NEW BRITAIN TOWNSHIP

Reference: 700 Manor Drive, Sketch Plan Review 1
TMP# 26-005-049-013 & -014

Reference: Frankel-McGinley – Lot Line Change Plan Review 1
267 Creek Road, TMP #26-011-024 (Frankel, 2.00 Acres)
283 Creek Road, TMP #'s 26-011-026 (McGinley, 10.93 Acres)

Reference: Casadonti Subdivision Sketch Plan Review 1
396 King Road, T.M.P. #26-004-030

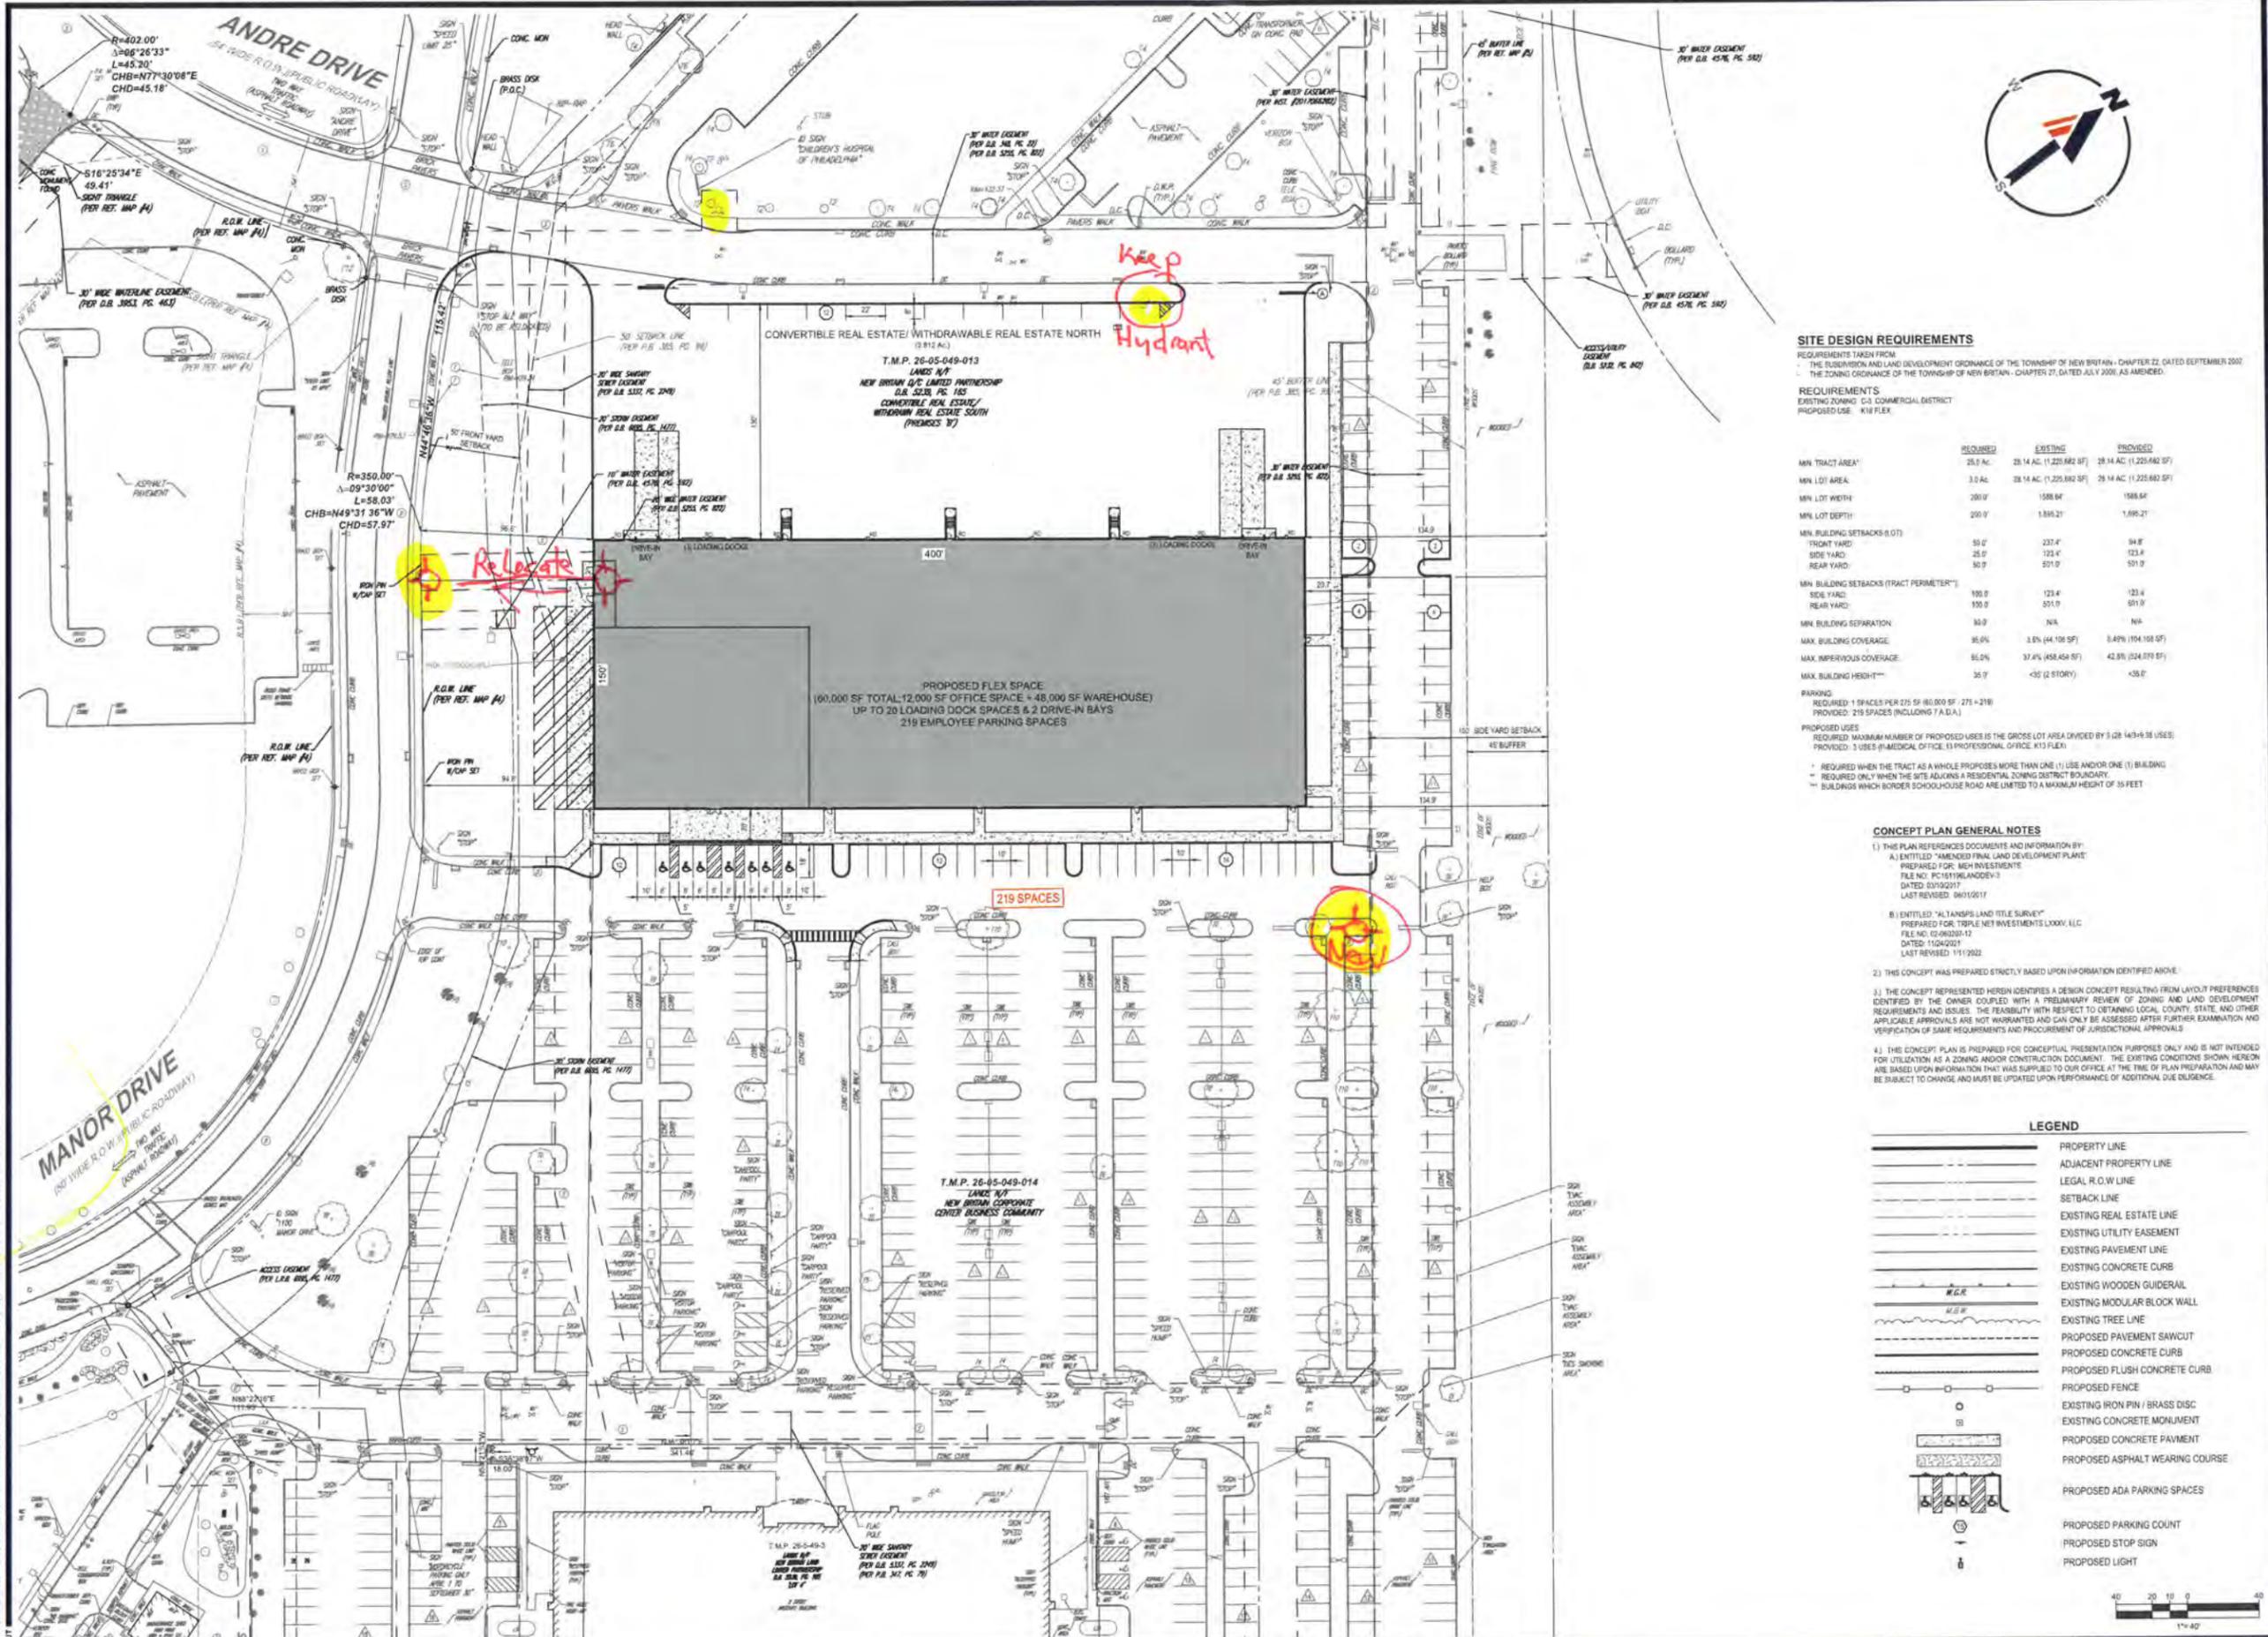
1. Show Fire line and water line on plan
2. Relocate existing hydrant that is inside of building out to Manor Drive
3. Supply one additional Fire Hydrant to the Southeast side of building as per enclosed plan

DATE	DRAWN BY	CHECKED BY	SCALE	F.B./PG.	JOB NO.	SHEET NO.
MARCH 24, 2022	DY	ADC	1" = 50'	56/44	5303, REF: 5199	1 OF 3

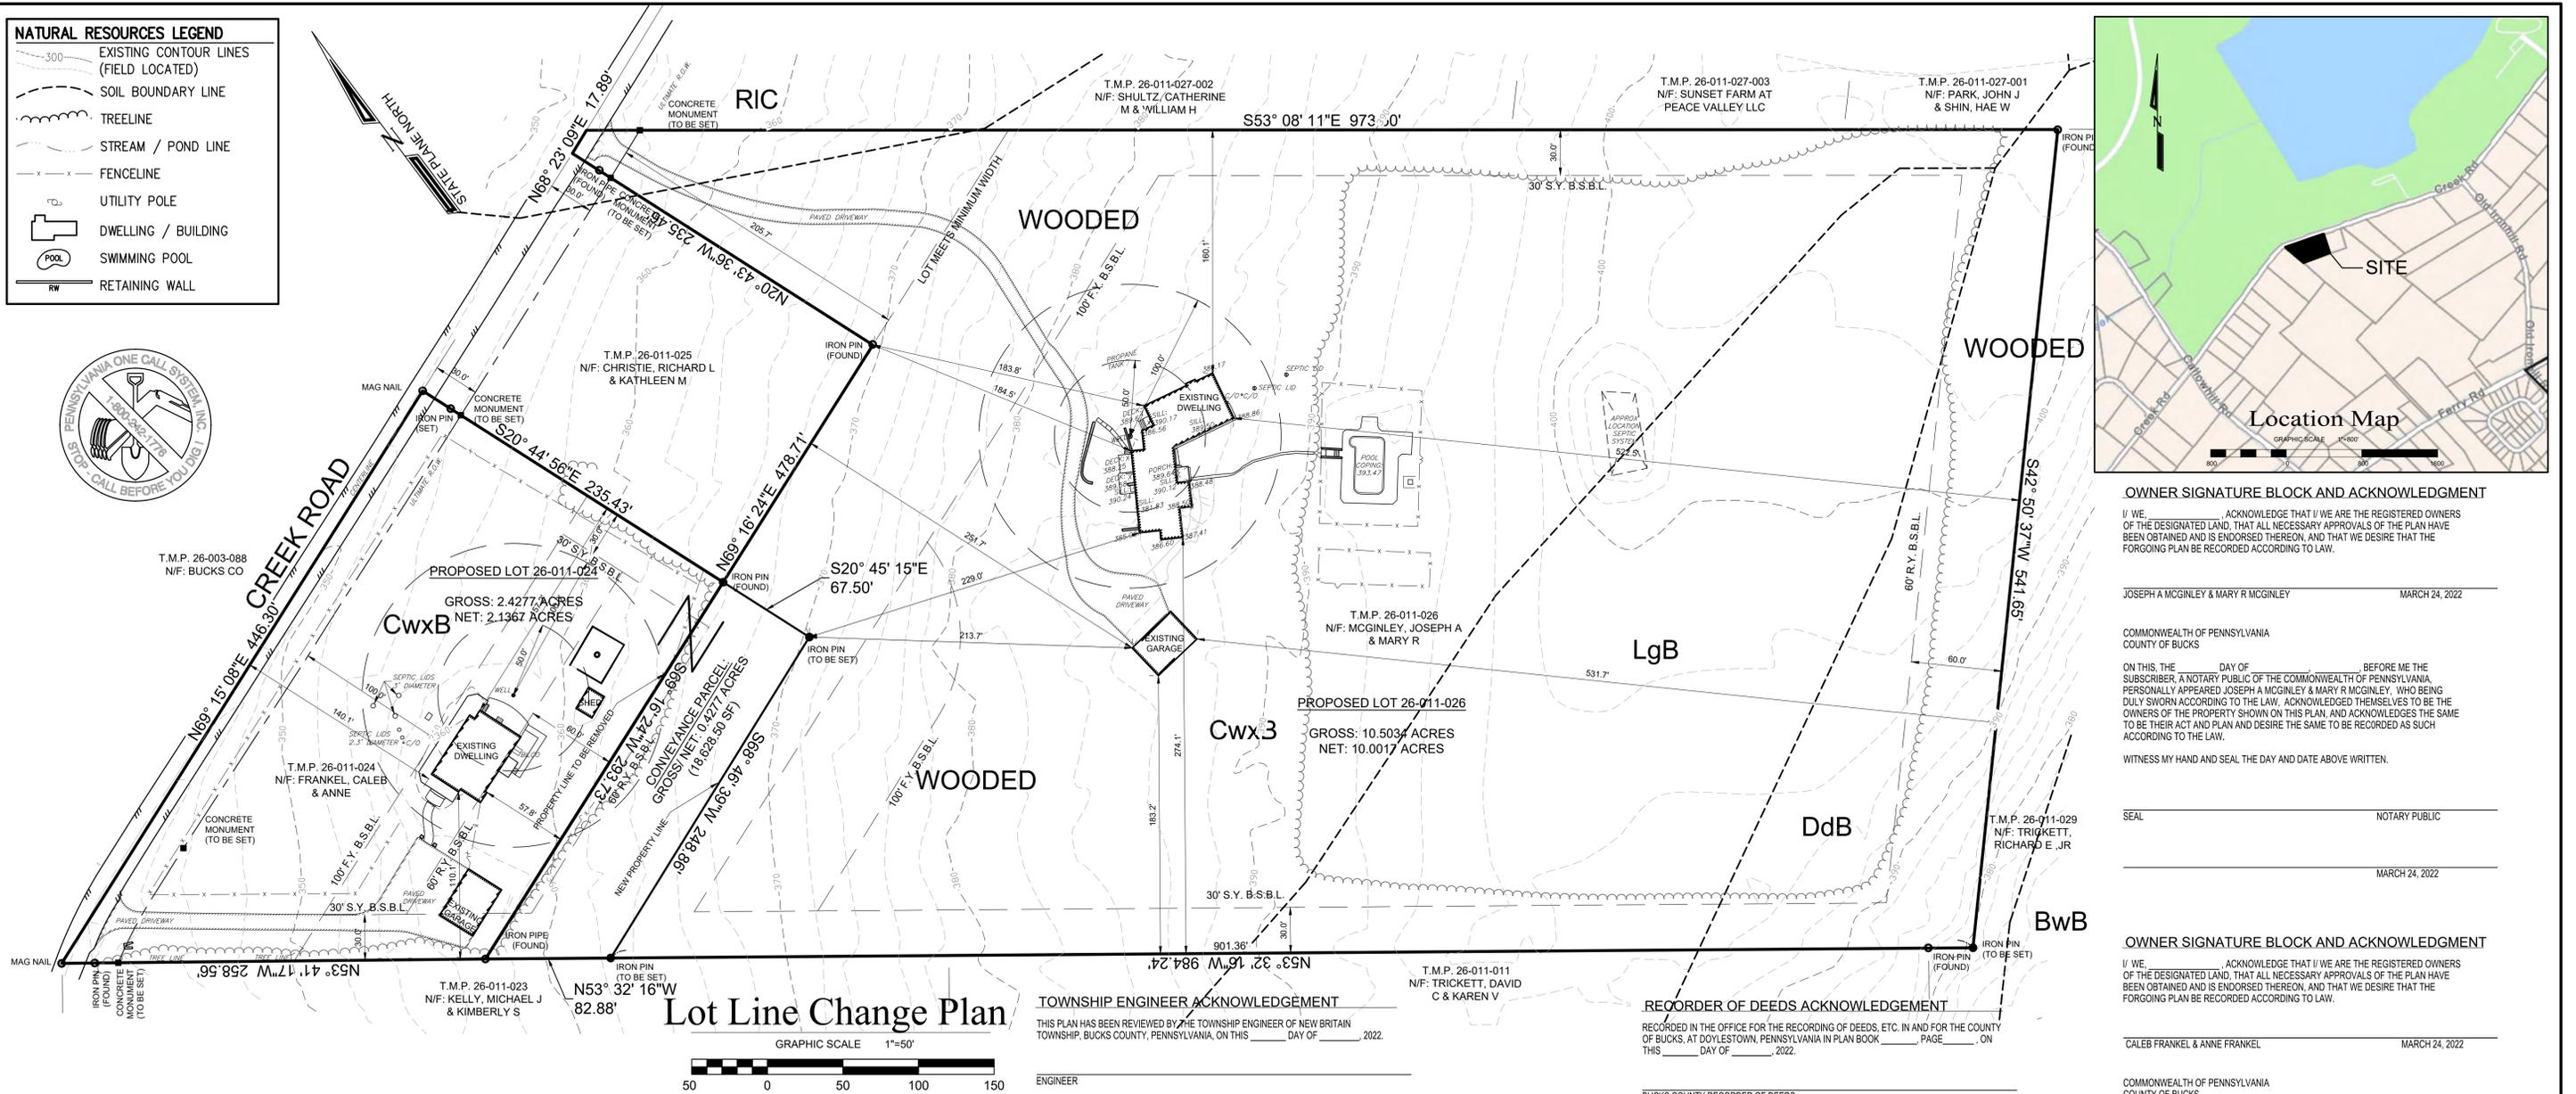
5. §22-502.1.B.(12) – The existing building coverage and impervious percentages provided in the Impervious tables on Sheet 1 shall include the existing lot areas prior to the lot line change and right-of-way dedication.

File No.	1734_C1.0.DWG
HCE Job	1734
Date	04/18/2022
Scale	1"=80'
Designed	EC
Sheet	1 of 2
Drawing No.	C0.1

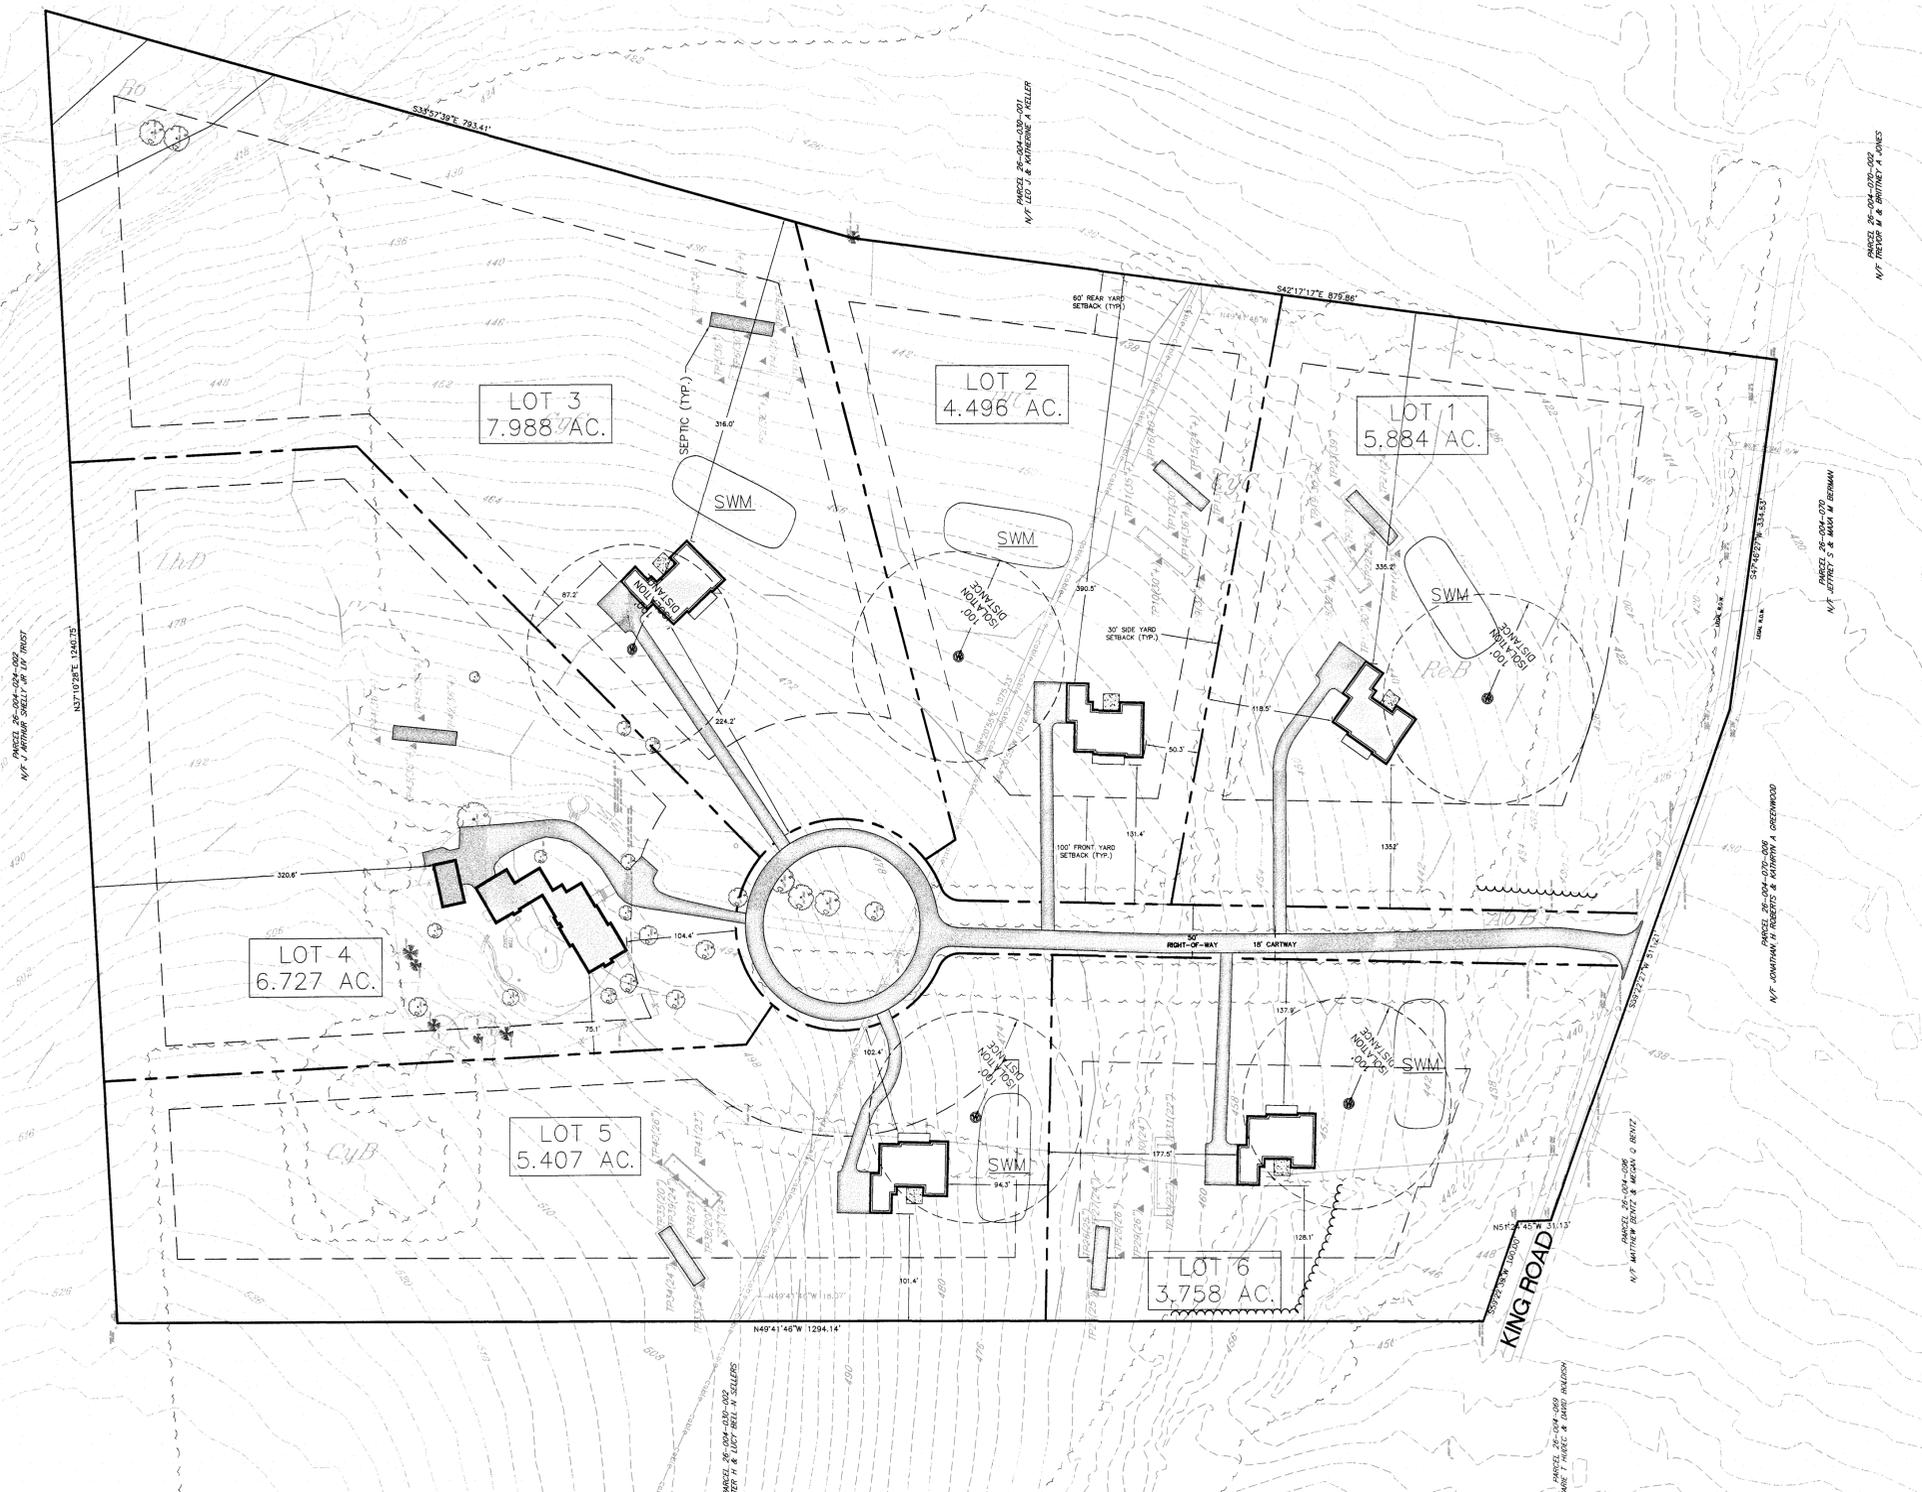
4. §27-2402.h – The Lot Area and Coverage Table on Sheet 1 shall be updated to subtract the ultimate right-of-way area for King Road and any resource with 100% protection ratio (watercourse, floodplain, riparian buffer, etc.) to determine the impervious surface ratio.
